HISTORIC AND DESIGN REVIEW COMMISSION

HDRC CASE NO: 2022-457
ADDRESS: 115 GORMAN ST
LEGAL DESCRIPTION: NCB 1666 BLK J LOT E 48.4 FT OF 3 & 4
ZONING: R-5
CITY COUNCIL DIST.: 2
DISTRICT: Dignowity Hill Historic District
APPLICANT: Cotton Estes/Cotton Estes Architect PLLC
OWNER: Pryce & Hannah Ancona/ANCONA PRYCE BELDING & HANNAH NOELLE
TYPE OF WORK: New construction of addition and carport
APPLICATION RECEIVED: August 18, 2022
60-DAY REVIEW: Not applicable due to City Council Emergency Orders
CASE MANAGER: Jessica Anderson

PROJECT:
ANCONA RESIDENCE/
THE COOTIE CATCHER HOUSE
115 GORMAN STREET
SAN ANTONIO TX 78202

1 DEMO FLOOR PLAN

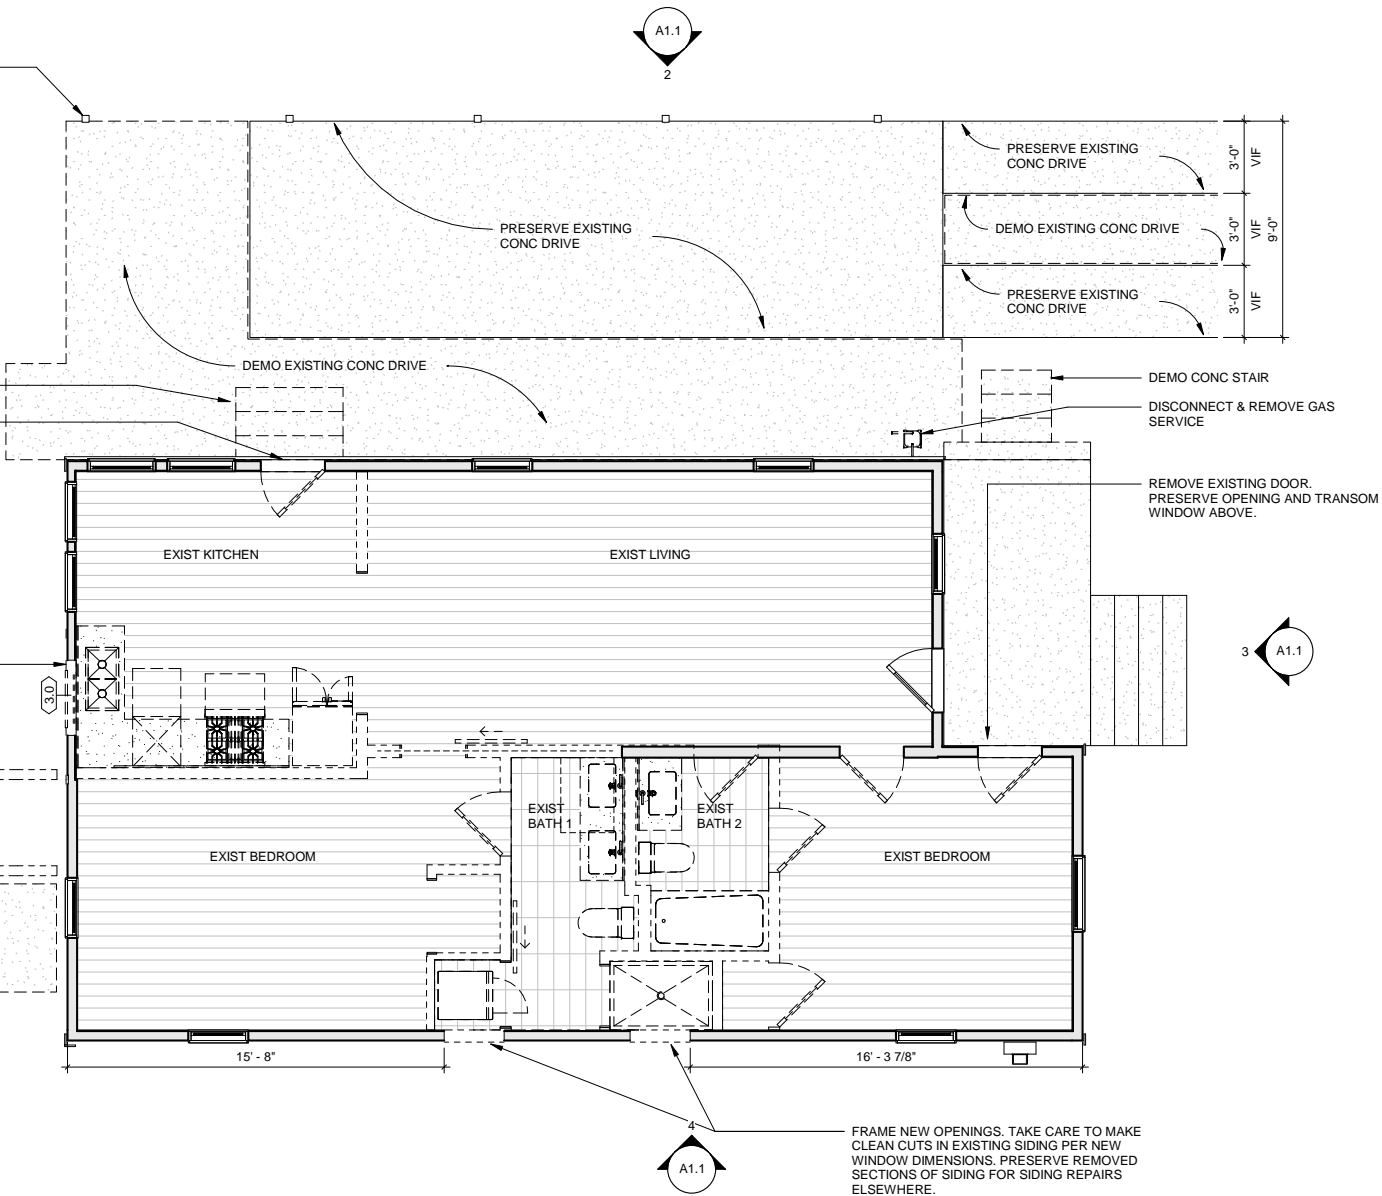
- g. **DOOR (PRIMARY):** The applicant proposes to remove the east-facing door on the front porch and replace it with a double-hung wood window while retaining the transom. Historic Design Guidelines for Exterior Maintenance and Alterations 6.A.1 says to preserve historic window and door openings, and 12.A.i says to preserve elements of historic buildings that are energy efficient. Two doors leading to a front porch is a character-defining feature of historic homes of this era, and as the configuration as it appears on this structure represents a method of passive cooling via ventilation. Staff finds the proposed door removal does not conform to guidelines.

Staff recommends denial of item 3, replacement of one door on the existing house with a salvaged double-hung wood window, based on finding g.

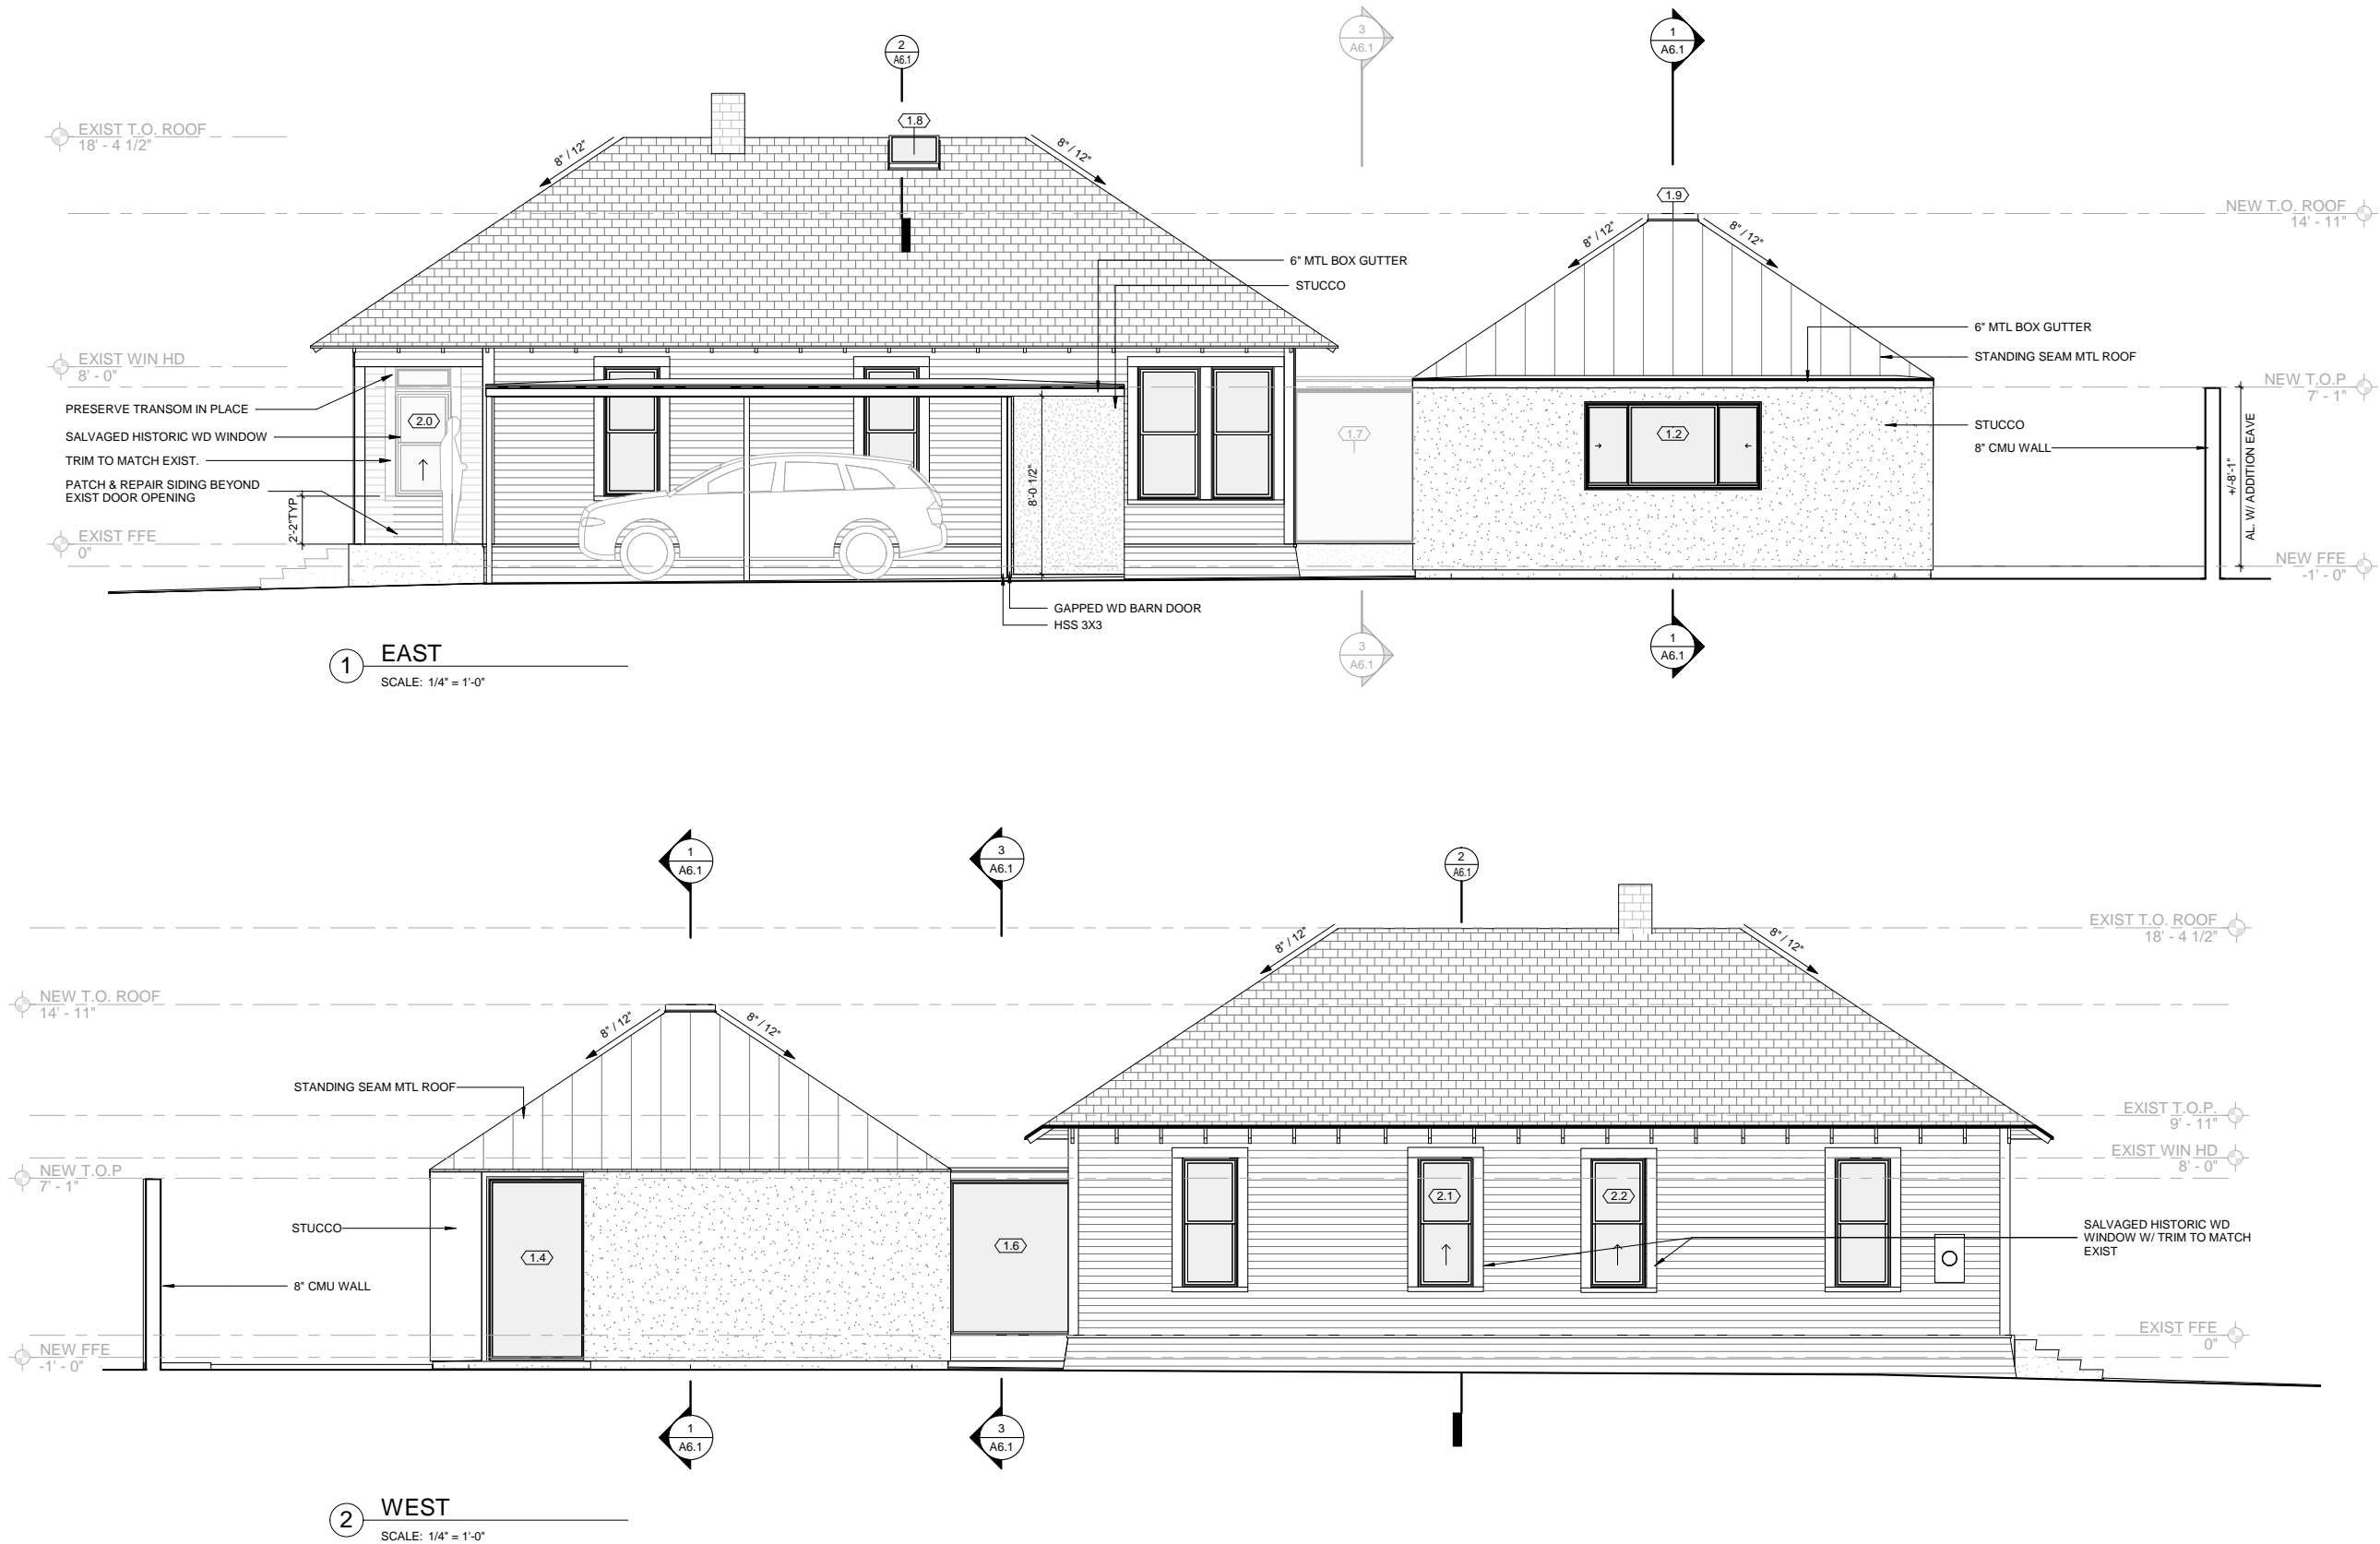
- c. **ROOF (ADDITION):** The applicant proposes a pyramidal standing seam metal roof with a flat membrane roof for the addition. The existing house has a composition shingle roof. Guideline 3.A.i states that materials introduced to a site as a result of an addition must be compatible with the architecture style and materials of the original structure. Staff finds the proposed addition does not conform to this guideline in terms of materials. Additionally, the applicant proposes a roof form with no eaves. Historic Design Guidelines for Additions 1.A.ii says to utilize a similar roof pitch, form, overhang, and orientation as the historic structure for additions. The applicant should introduce eaves in keeping with the roof form on the existing house.

- d. **MATERIALS: CLADDING (ADDITION):** The applicant proposes stucco cladding for the addition. The existing house is clad in wood waterfall siding. Guideline 3.A.i states that materials introduced to a site as a result of an addition must be compatible with the architecture style and materials of the original structure. Staff finds the proposed addition does not conform to this guideline. While a stucco clad addition would be appropriate for a house of masonry construction or cladding, staff finds a wood-clad addition would be more appropriate for this site.

- e. **WINDOWS AND DOORS (ADDITION):** The applicant proposes aluminum-clad wood windows and doors for the addition, including a glass corridor connecting the existing house and the addition. The north elevation (rear) of the addition is dominated by central sliding glass doors flanked by fixed glass windows, with a sliding window to the east under the flat roof. The south elevation has a glass door with a full-height lite to the left. The east elevation has a tripartite window with sliding panes. Staff finds the doors in their locations on the addition generally appropriate. Windows in the existing home are primarily one-over-one wood windows. Standard Specifications for Windows in Additions and New Construction state that new windows on additions should relate to the windows of the primary historic structure in terms of materiality and overall appearance. Staff finds the addition does not conform to these stipulations.

- i. That the applicant use composition shingle on the pyramidal roof form in keeping with the architecture style and materials of the original structure.
- ii. That the applicant use wood cladding in keeping with the architecture style and materials of the original structure.
- iii. That the applicant use windows that relate to those found on the primary historic structure, namely one-over-one windows.
- iv. That the applicant introduce eaves in keeping with the roof form on the existing house.
